SERVICE BULLETIN

N° 139-723

ATA 53 - CABIN PROVISION MODIFICATION

This Service Bulletin is issued in order to provide the necessary instructions on how to perform the installation of 4th seat rail structural provision P/N 3G5311A64811 Rev. B, IPSL structural provision P/N 3G5311A64911 Rev. B and fire extinguisher structural provision P/N 3G2620A06511 Rev. A, in order to permit a different seats configuration and to install the fire extinguisher.

Figure 1

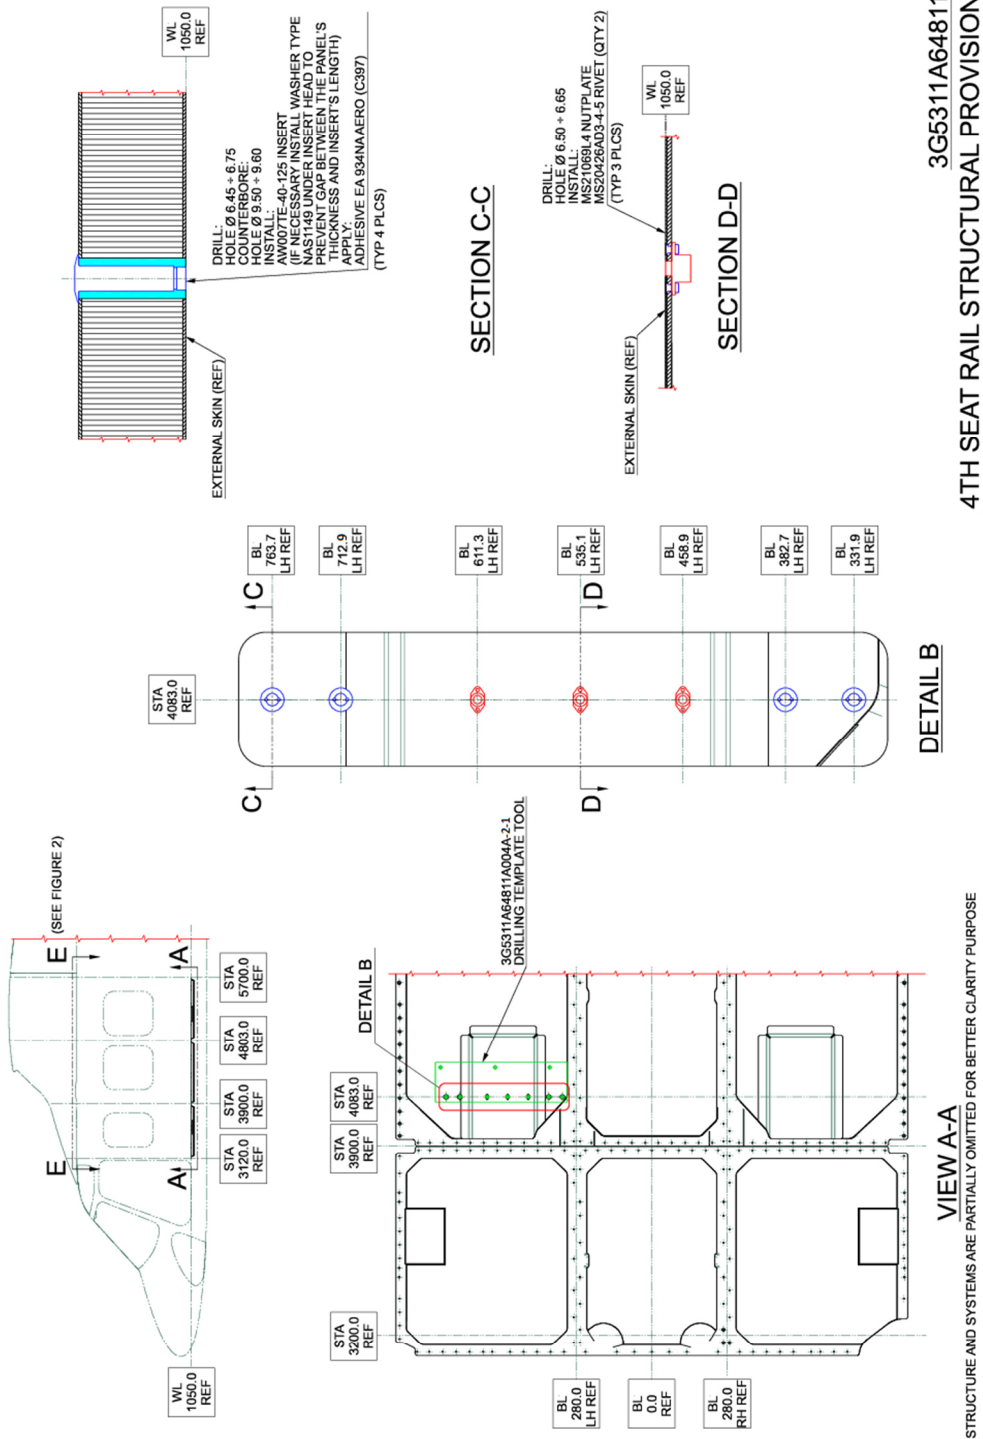
- 2.1 With reference to Figure 1 View A-A, Section C-C and Section D-D, temporarily locate the drilling template tool P/N 3G5311A64811A004A-2-1 on the panel and pilot the n° 7 holes with a #30 drill through the panel.

- 2.2 Drill n° 4 holes $\varnothing 6.45 \div 6.75$ and n°3 holes $\varnothing 6.50 \div 6.65$ thru the panel.
 - 2.3 With reference to Figure 1 Section C-C, counterbore the n°4 holes to $\varnothing 9.50 \div 9.60$.

- 2.4 With reference to Figure 1 Section C-C, install n°4 inserts P/N AW007TE-40-125

- on the panel by means of adhesive EA 934NA Aero (C397).
- 2.5 With reference to Figure 1 Section D-D install n°3 nut plates P/N MS21069L4 on the panel by means of n°6 rivets P/N MS20426AD3-4-5.
 - 2.6 With reference to Figure 2 View J and View K1, remove the nut plate P/N MS21069L3 and the existing rivets from the LH angle lower.
 - 2.7 With reference to Figure 2 Section L-L, countersink the hole and install the rivet P/N NAS1097AD6-5 on the LH angle lower.

Figure 3

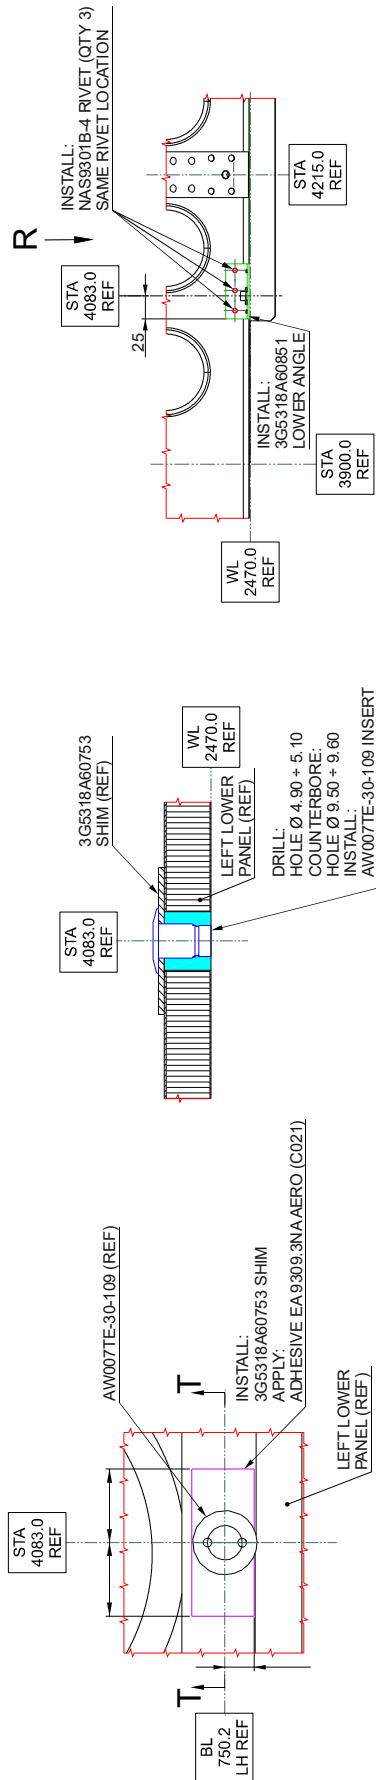
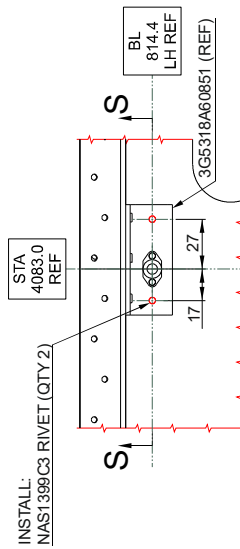
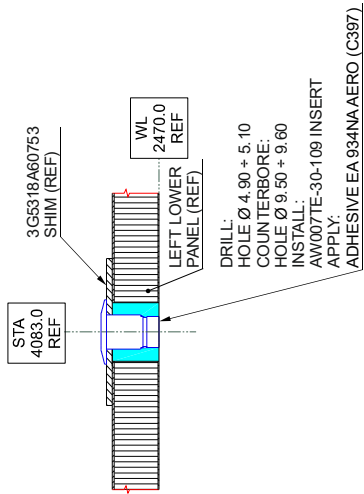
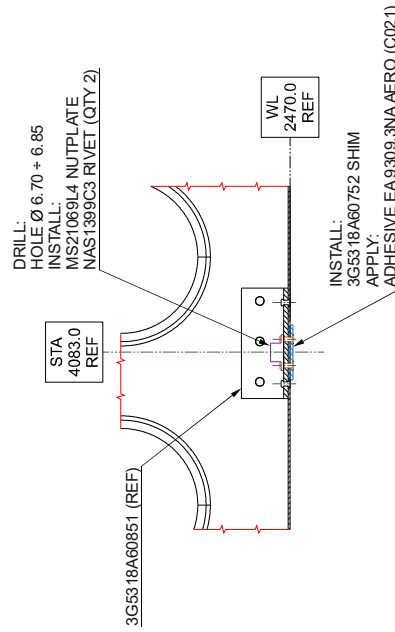
- 2.13 With reference to Figure 3 Section T-T, counterbore the hole to $\varnothing 9.50 \div 9.60$.
- 2.14 With reference to Figure 3 Detail H, install the shim P/N 3G5318A60753 on the panel by means of adhesive EA 9309.3NA Aero (C021).

- 2.15 With reference to Figure 3 Section T-T, install the insert P/N AW007TE-30-109 on the shim P/N 3G5318A60753 and on the panel by means of adhesive EA 934NA Aero (C397).

- 2.19 With reference to Figure 3 View P and View R, install the lower angle P/N 3G5318A60851 on the longeron by means of n°3 rivets P/N NAS9301B-4 and n°2 rivets P/N NAS1399C3.

- 2.20 With reference to Figure 3 Section S-S, install the shim P/N 3G5318A60752 on the longeron by means of adhesive EA 9309.3NA Aero (C021).
 - 2.21 With reference to Figure 3 View R and Section S-S, drill n°1 hole $\varnothing 6.70 \div 6.85$ thru the lower angle P/N 3G5318A60851, the longeron and the shim P/N 3G5318A60752 according with dimensions shown.

- 2.22 With reference to Figure 3 Section S-S, install the nut plate P/N MS21069L4 on the lower angle P/N 3G5318A60851 by means of n°2 rivets P/N NAS1399C3.

Figure 4

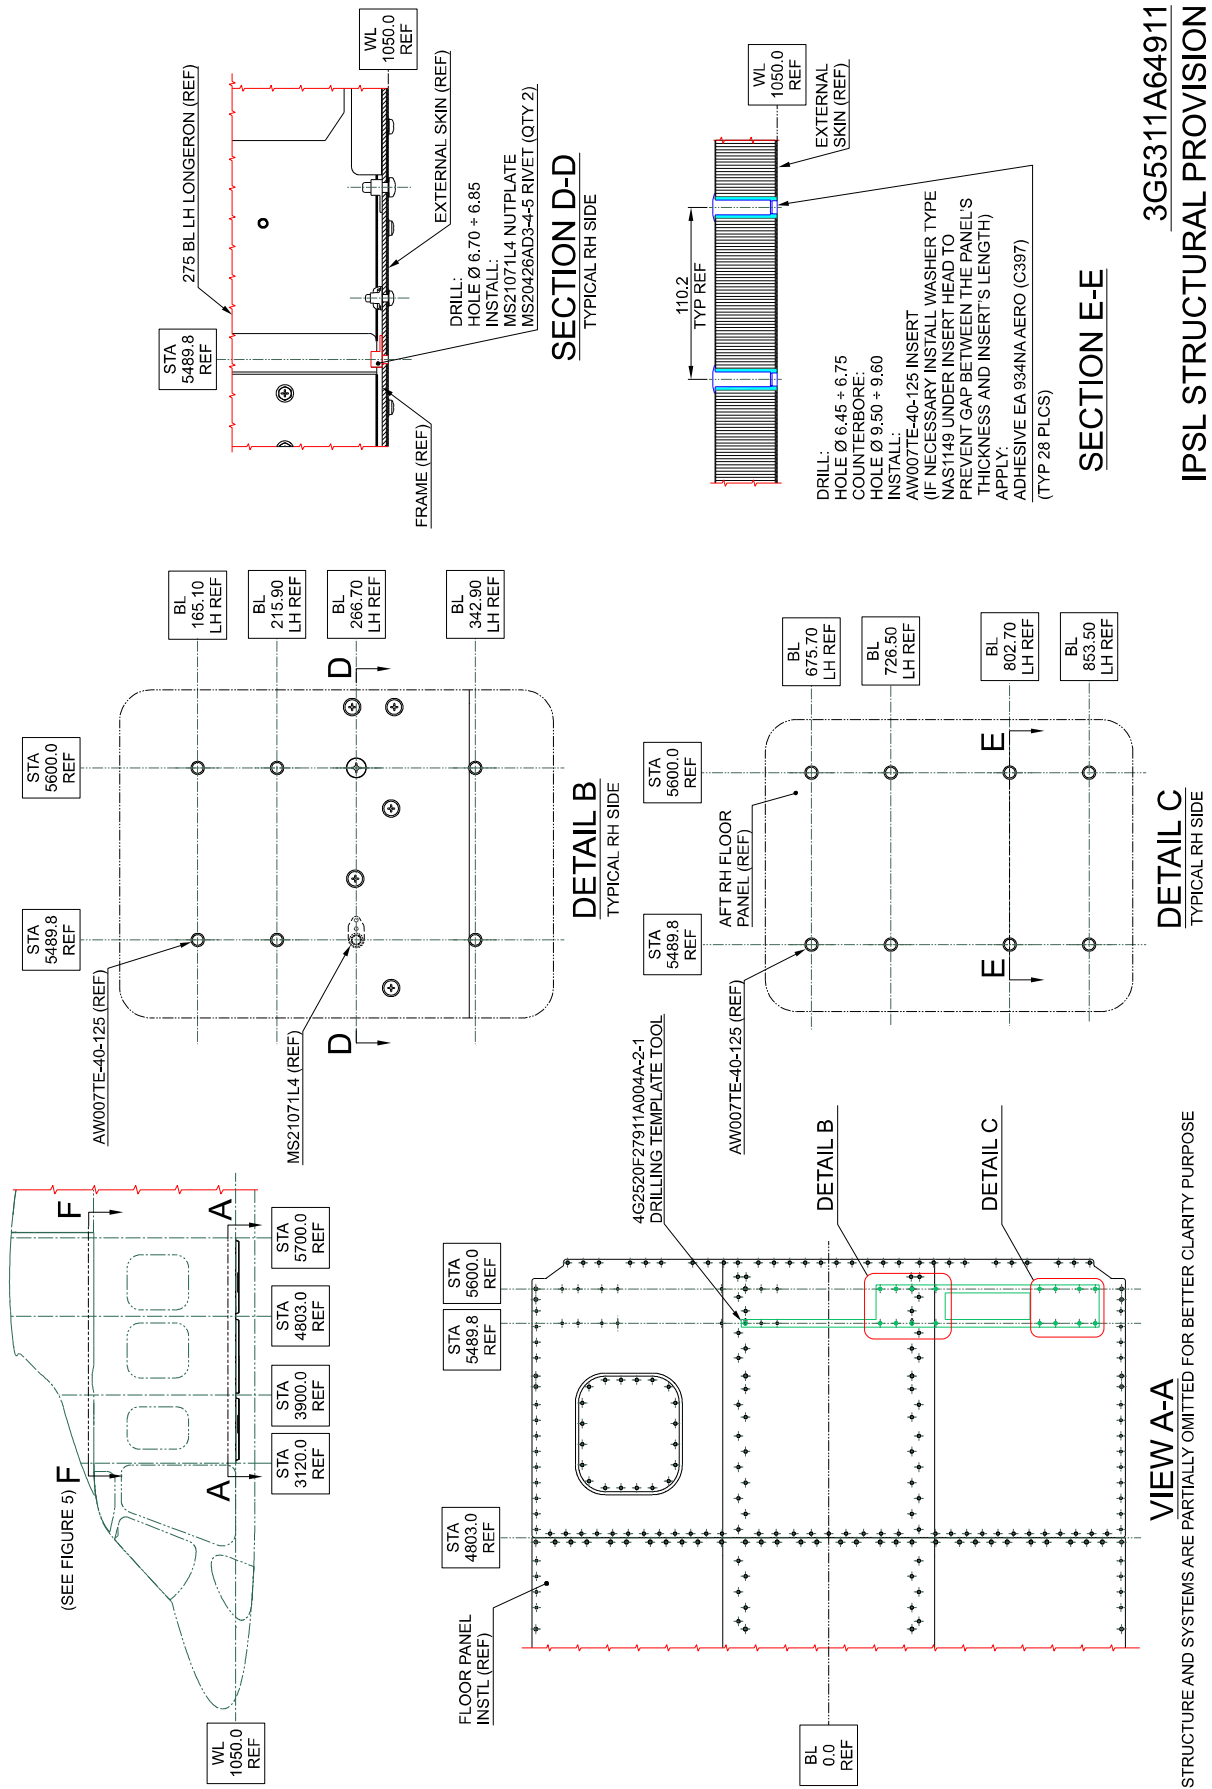
- 3.1 With reference to Figure 4 View A-A, section D-D and Section E-E, temporarily locate the drilling template tool P/N 4G2520F27911A004A-2-1 on the aft RH floor panel and pilot the n° 15 holes with a #30 drill through the panel.

- 3.2 With reference to Figure 4 View A-A, section D-D and Section E-E drill n°1 hole $\varnothing 6.70 \div 6.85$ and n°14 holes $\varnothing 6.45 \div 6.75$ thru the aft RH floor panel.

- 3.3 With reference to Figure 4 Section E-E, counterbore the n°14 holes to $\varnothing 9.50 \div 9.60$.

- 3.4 With reference to Figure 4 Section E-E, install n°14 inserts P/N AW007TE-40-125 on the aft RH floor panel by means of adhesive EA 934NA Aero (C397).
- 3.5 With reference to Figure 4 Section D-D, install the nut plate P/N MS21071L4 on the frame at STA 5489.8 and BL 266.70 by means of n°2 rivets P/N MS20426AD3-4-5.
- 3.6 Repeat step from 3.1 thru 3.5 for the aft LH floor panel.
- 3.7 With reference to Figure 5 View F-F, Detail G and Section H-H, temporarily locate the drilling template tool P/N 4G2520F27911A004A-1-1 on the panel and pilot the n° 7 holes with a #30 drill through the panel.
- 3.8 With reference to Figure 5 View F-F, Detail G and Section H-H drill n°1 hole $\varnothing 4.90 \div 5.05$ and n°6 holes $\varnothing 6.45 \div 6.75$ thru the panel.

Figure 5

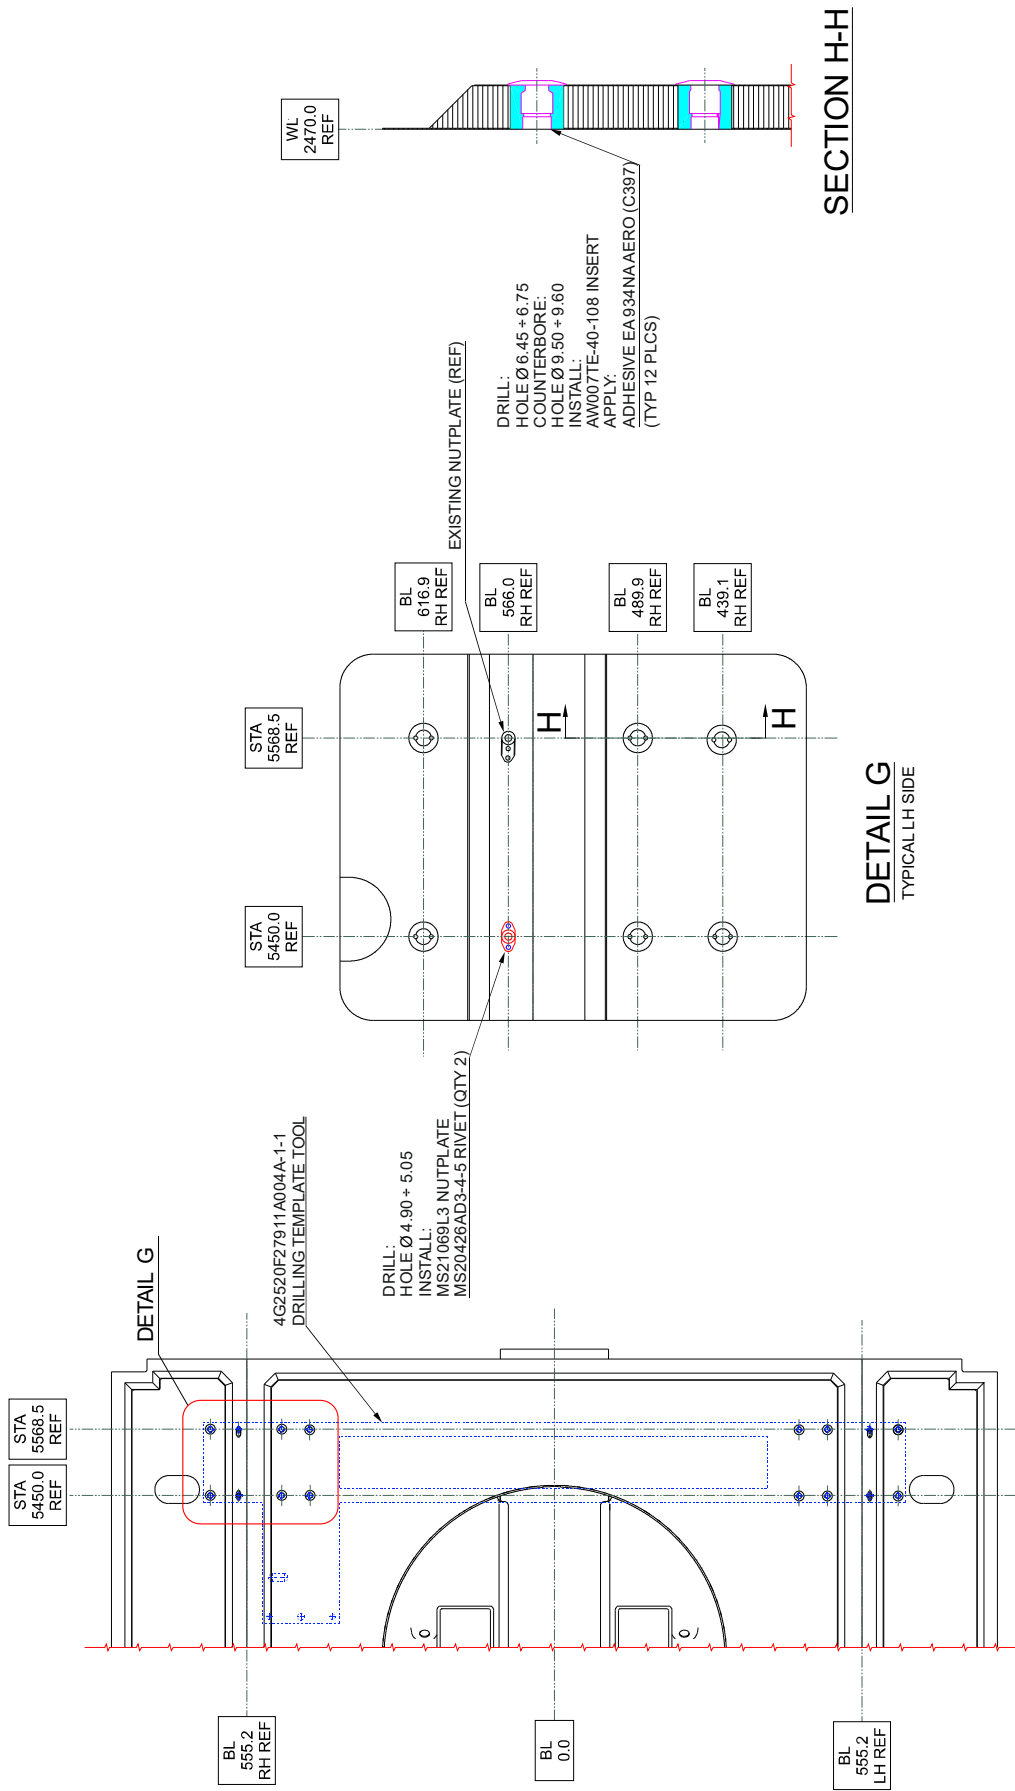
- 3.9 With reference to Figure 5 Section H-H, counterbore the n°6 holes to $\varnothing 9.50 \div 9.60$.
- 3.10 With reference to Figure 5 Section H-H, install n°6 inserts P/N AW007TE-40-108 by means of adhesive EA 934NA Aero (C397).
- 3.11 With reference to Figure 5 Detail G, install the nut plate P/N MS21069L3 by means of n°2 rivets P/N MS20426AD3-4-5.
- 3.12 Repeat steps from 3.5 thru 3.11 for the LH side.
4. In accordance with AMP DM 39-A-06-41-00-00A-010A-A, re-install all external panels, internal panels and internal liners previously removed.
5. Return the helicopter to flight configuration and record for compliance with Part I of this Service Bulletin on the helicopter logbook.
6. Send the attached compliance form to the following mail box:

Figure 6

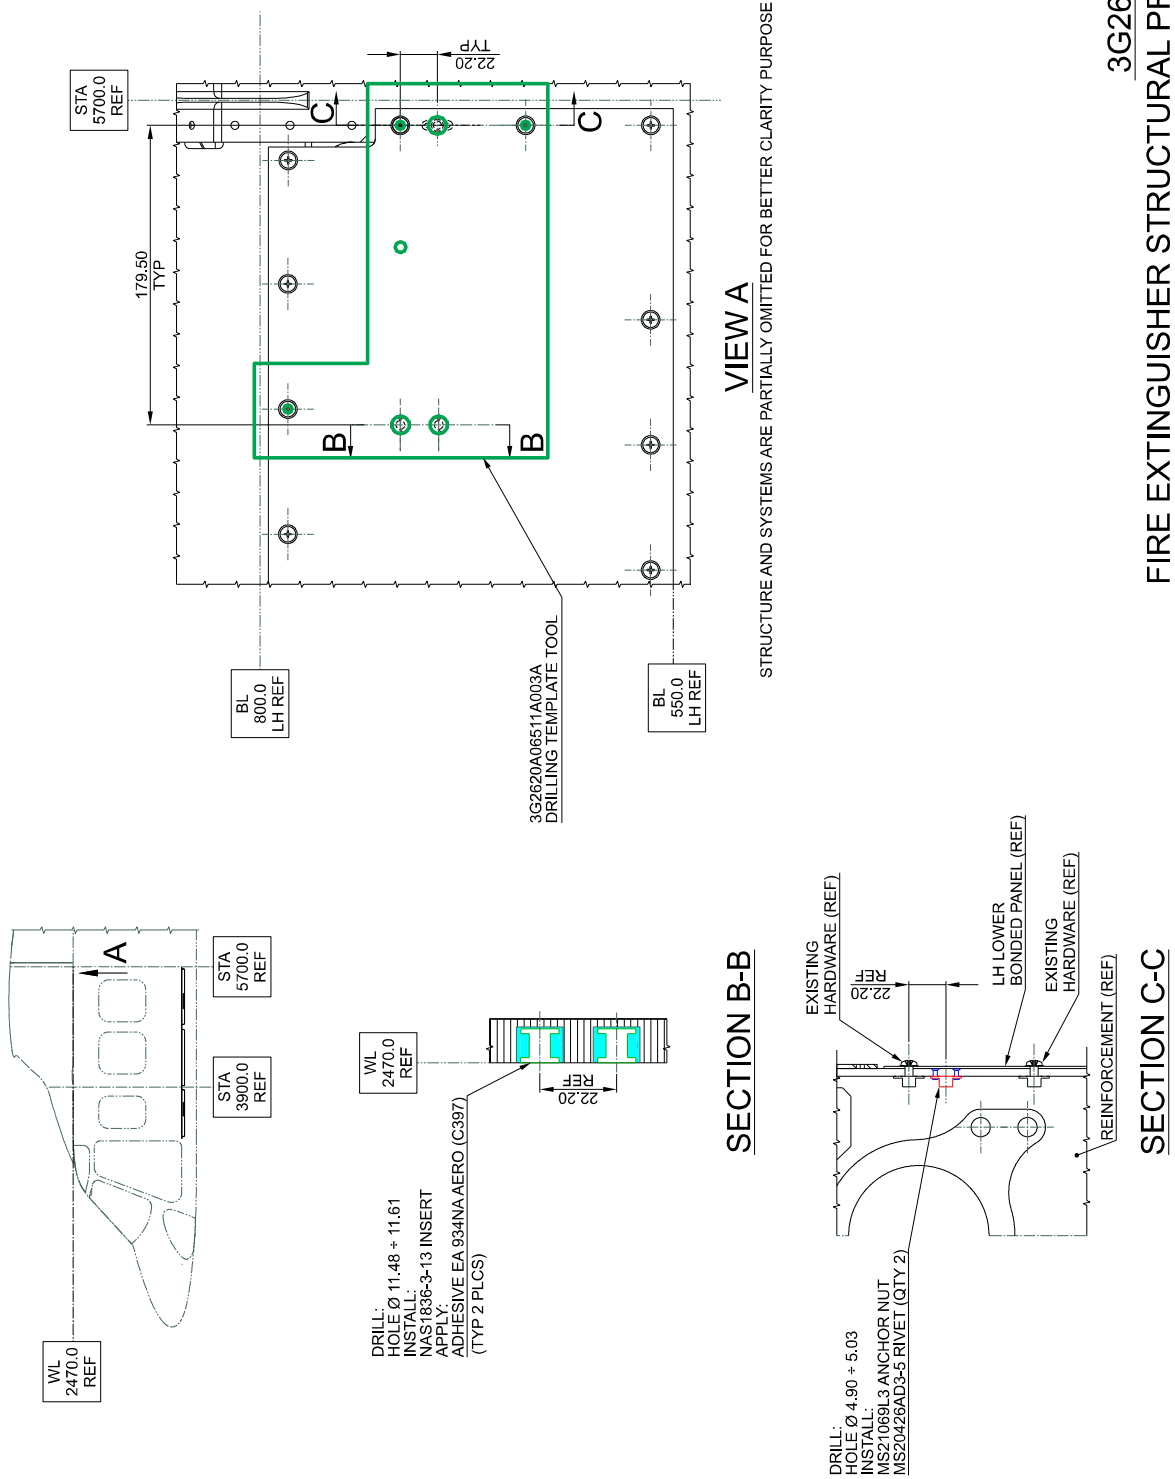
- 2.1 With reference to Figure 6 View A, Section B-B and Section C-C, temporarily locate the drilling template tool P/N 3G2620A06511A003A on the LH lower bonded skin and pilot the n° 2 insert holes with a #30 through the lower bonded skin and drill the nut plate hole with a #30 through the panel and frame.

- 2.2 With reference to Figure 6 View A, Section B-B and Section C-C drill n°2 insert holes to $\varnothing 11.48 \div 11.61$ thru the L/H lower bonded skin and n°1 nut plate hole to $\varnothing 4.90 \div 5.03$ through the panel and frame according with dimensions shown.

- 2.3 With reference to Figure 6 Section B-B, install n°2 inserts P/N NAS1836-3-13 on the LH lower bonded panel by means of adhesive EA 934NA Aero (C397).

- 2.4 With reference to Figure 6 Section C-C, install the anchor nut P/N MS21069L3 on the frame REF. STA 5685 and BL 694.00 by means of n°2 rivets P/N MS20426AD3-5.
